INITIAL FIRE SAFETY INSPECTION REPORT

Factory Name: Hop Lun Apparel Limited (Extension)

RSC ID: 25664

Date: 28-March-24

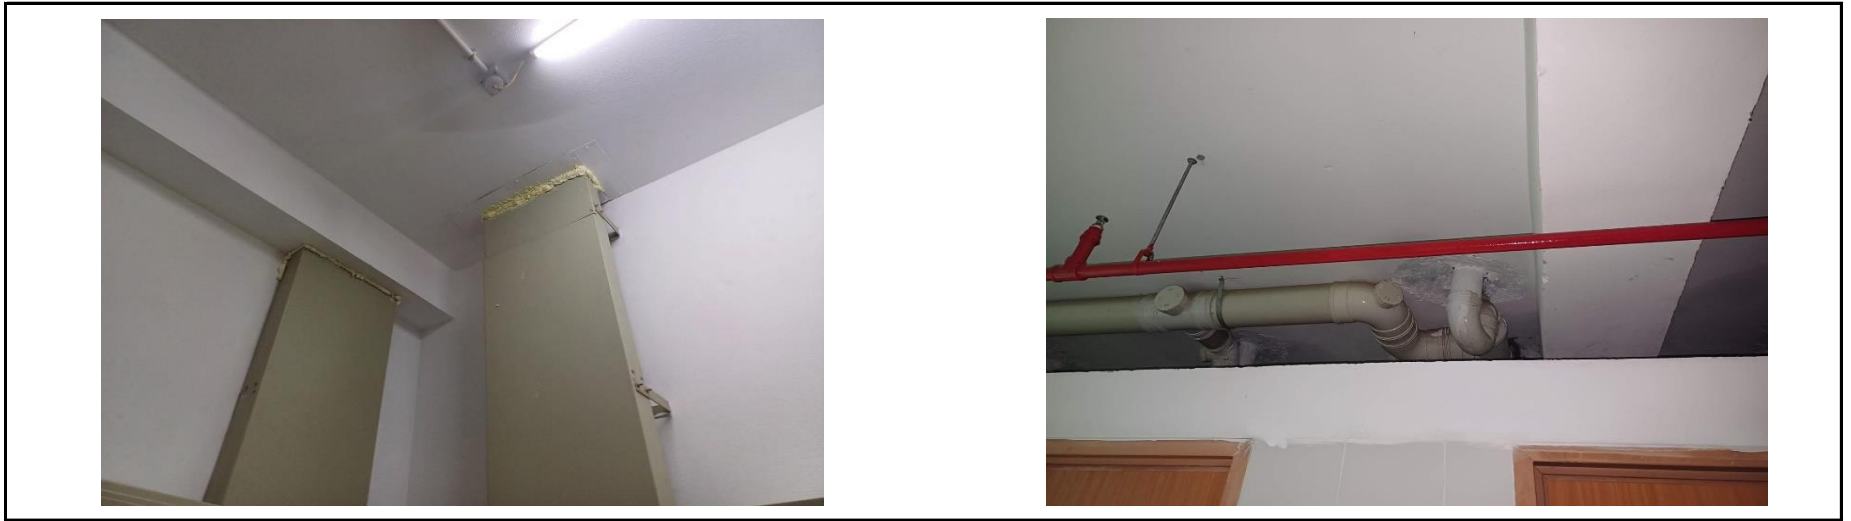
SI No.	Category	Findings	Required Action	Remediation Time Frame
1	Fire Rated Construction	Store room discharged directly into the exit stair enclosures.	Openings from exit enclosure to storage shall be provided with a vestibule with fire rated construction and openings. Provide a 2 hr. fire rated door on the exit stair side and a 1- hr. fire rated door on the storage side. Ensure that the fire rating of the vestibule construction matches that of the exit stair enclosure.	Within 3 months
